Nº 166 Service Bulletin

DATE: September 20, 2006

SUBJ: Grand Prix / NASCAR®
Trough Up-Kicker Failure

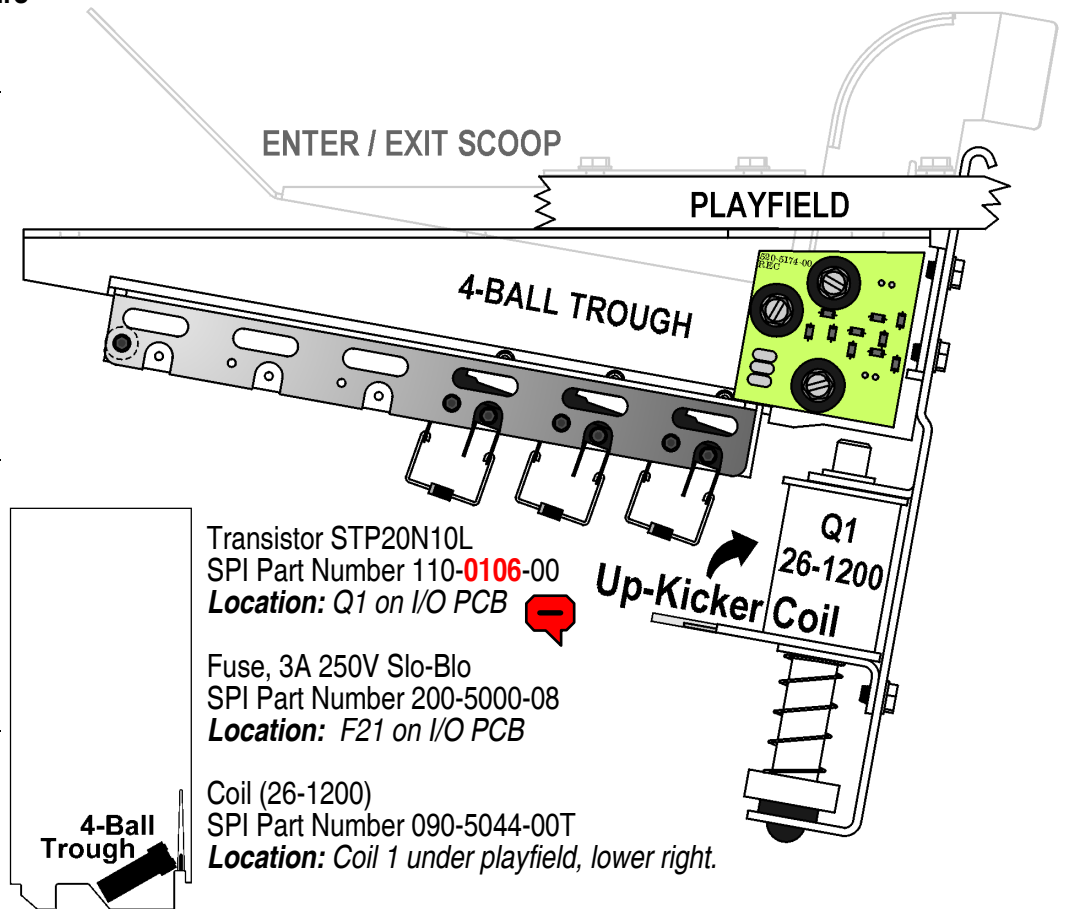
- Game will not start.
- 50VDC coils are inoperable.
- I/O Power Driver PCB F21 3A 250V SLO-BLO Fuse is blown.
- Trough Up-Kicker (Coil #1) is overheating (paper wrap is browned).
- Q1 Transistor STP20N10L (on I/O PCB) is shorted.

The Game Software Version **4.20** or lower (U210 on the CPU/Sound Board II) has a problem in which it may repetitively fire the Trough Up-Kicker Coil when serving the ball up to the Shooter Lane.

Ensure your Game Code on your CPU/Sound Board in location U210 is **v4.50+** and replace all faulty components.

If you do not have an ePROM Burner, you'll need to order the latest version on an EPROM from your local distributor. Ask for SPI Part Number 960-5009-00 and specify if you need Grand Prix or NASCAR Game Code.
